"NRC Technical Assistance
for Design Reviews"
Contract No. NRC-02-85-002
FIN D1016

ITASCA TRIP REPORT

PURPOSE: NRC/SRP Meeting on ESF Design

FIG. 1 SRPO Logic Diagram for Effects of Requirements on ES Construction

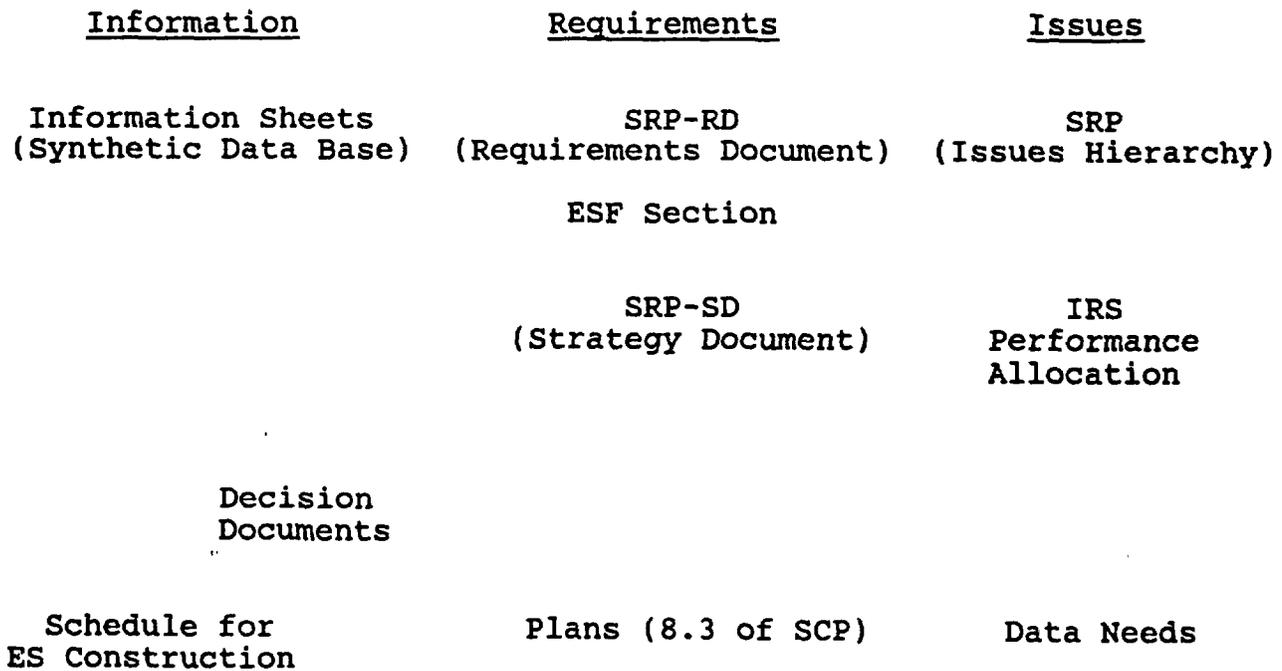
This diagram (Fig. 1) brought up several questions regarding the SCP and the ES design which will be presented in it. DOE stated that the Title I (preliminary) design will be presented in the SCP—not the Title II design, which will be completed by that time. NRC expressed the concern that the Title II design needs to be addressed in the SCP. In response to the questions from that day, DOE provided the following.
